Asataranga Nodal school Astaranga Puri

Audit Report

2. Alighting

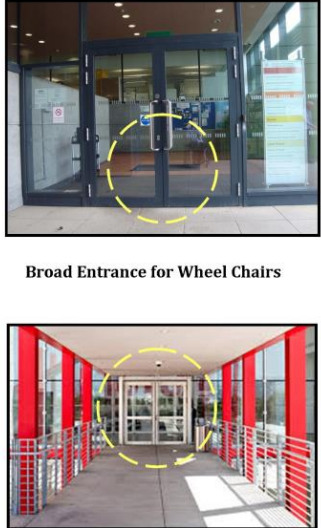
No lighting space.	Traffic police to be requested to allow extra parking time for entry and exit from vehicles.
--------------------	--

4. Entrance

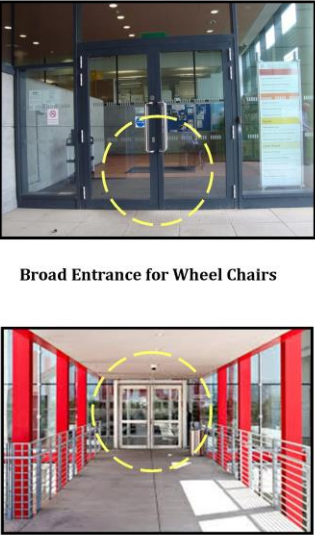
Issues Observed	Photograph	Recommendation	Technical Recommendation
<ol style="list-style-type: none"> 1. Landing space is 1500 mm X 1500 mm. 2. Inaccessible Concrete handrail in ramp 3. No Signage near entrance 4. No difference in floor finish. 5. No signage 6. Inaccessible ram available in entrance 		<ol style="list-style-type: none"> 1. Accessible ramp to be reconstruct at the entrance left of faculty block with 1:12 gradient, accessible handrail and tactile tiles. 2. Accessible ramp to be construct in all building entrance 3. Floor finish to be distinguished (suggestion – thin rubber mat). 4. Door mat should avoid. 5. Illumination of 150 lux 	<p>SI# 4 Accessible Entrance Examples of Best Practises</p>  <p style="text-align: center;">Broad Entrance for Wheel Chairs</p>

10. Classrooms

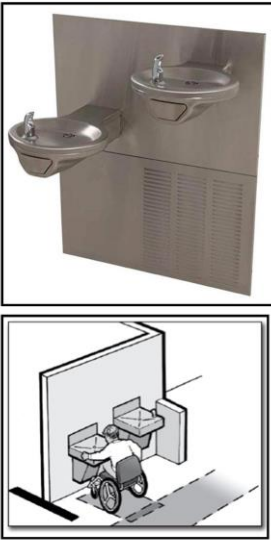
Issues Observed	Photograph	Recommendation	Technical Recommendation
<ol style="list-style-type: none"> 1. Inaccessible furniture and blackboard in classrooms. 2. Blackboard height 762 mm 		<ol style="list-style-type: none"> 1. 900 mm height, 900mm wide and 1200mm deep clear space in front of the book issue counter 2. should have adequate space for the wheelchair of 1500mm in the reading room 3. There should be a gap of 1200mm between book shelves. 4. Jaws software to be install in at list 5 computers. 5. There should be audio books and braille books. 6. Black board height should be in 900 mm to 1200 mm 7. There should be proper illumination of 250 lux in class room. 8. There should be 1200 mm space to move the wheel chair in the classroom. 9. Teacher should be trained to teach student with disability. 	<p data-bbox="1713 327 1982 406">Sl# 14 Cafeteria Examples of Best Practises</p>  <p data-bbox="1736 933 1982 981">Accessible Tables in the Cafeteria Highlighted circle shows knee space for wheel chair users</p>
